City of Aurora Building Division
Reviewed for Code Compliance
Approved as Noted: M. Apodaca
Date: May 16, 2022
2021 INTERNATIONAL CODES & 2020 NEC
FIRE/LIFE SAFETY REVIEW ONLY

City of Aurora Building Division
Project: *Antennae modifications*
Address: *1501 S. Potomac St.*
Occupancy Group: *U*
Construction Type: *V-B*
RSN: *1615733*
Permit: *22-2127528 LT*

SITE NAME: HUMANA
FA NUMBER: 10093833
SITE NUMBER: COL01176
ADDRESS: 1501 SOUTH POTOMAC
AURORA, CO 80045
SCOPE: 5G NR 1SR CBAND - MRUTH049238 (3755A12GGB)
5G NR 1SR CBAND - MRUTH049075 (3755A12GGA)

PROJECT TITLE:
HUMANA
FA# 10093833
SITE# COL01176

SOUTH ELEVATION VIEW (1)
SCALE: 1" = 25'

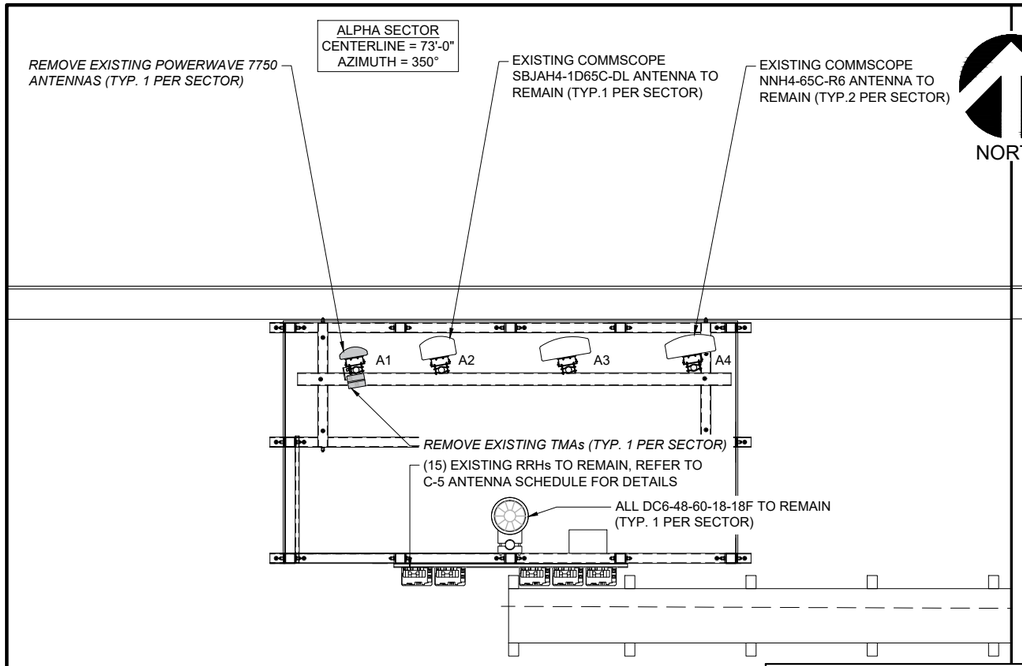
Elevation changes require separate Zoning approval

TYPICAL GROUND BAR CONNECTION DETAIL (3)

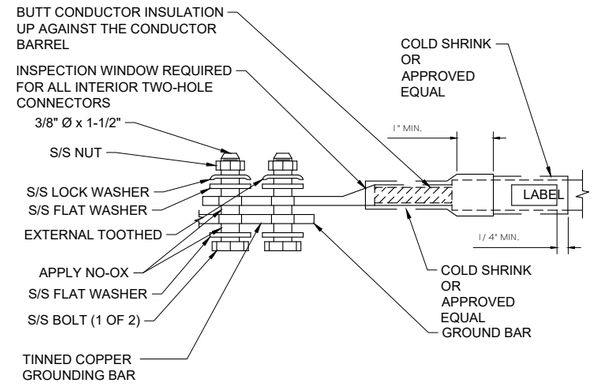
Provide a Grounding Electrode System bonded
To the service equipment enclosure, grounded
Conductors, and grounded electrode conductors
Per 2020 NEC 250.50 and 250.104

SCHEMATIC DIAGRAM GROUNDING SYSTEM (2)
SCALE: NTS

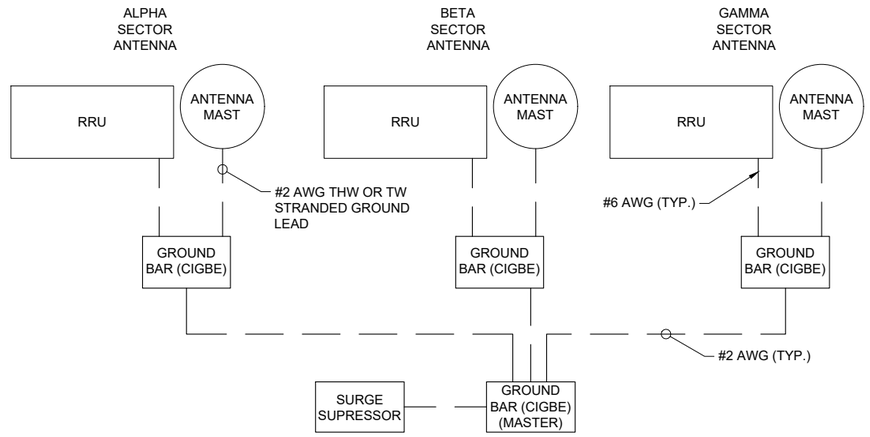
Provide a Grounding Electrode System bonded
To the service equipment enclosure, grounded
Conductors, and grounded electrode conductors
Per 2020 NEC 250.50 and 250.104
